STAFF REPORT

RE: Lot 4, Waukee Market Place Plat 1 – Site Plan

DATE: June 27, 2017

ABOVE: Aerial of the site plan (outlined in **BLUE**) in relation to the surrounding properties.

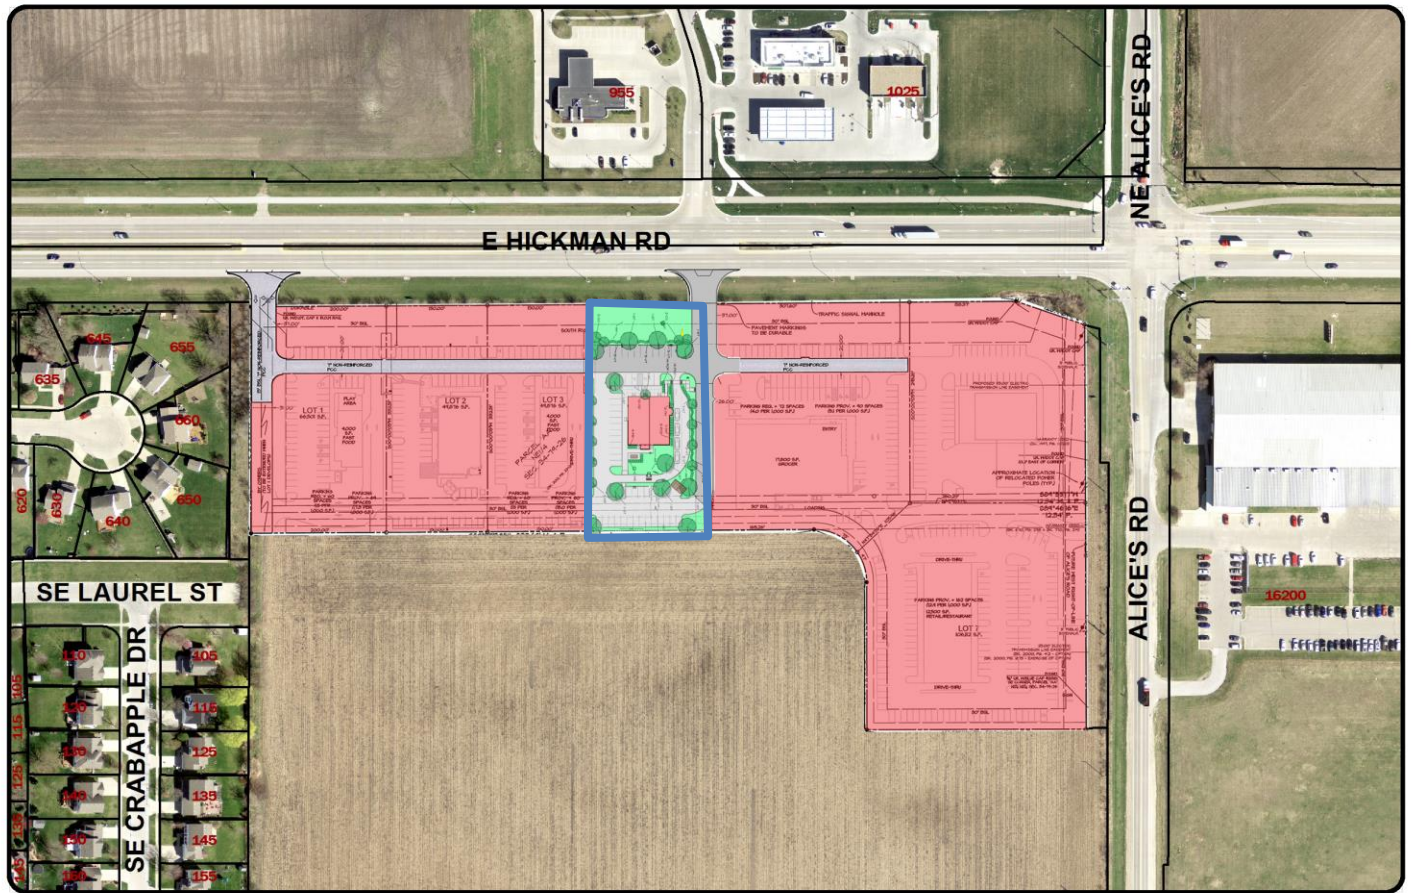
Property is generally located south of Hickman Road and west of SE Alice's Road, containing approximately 1 acre.
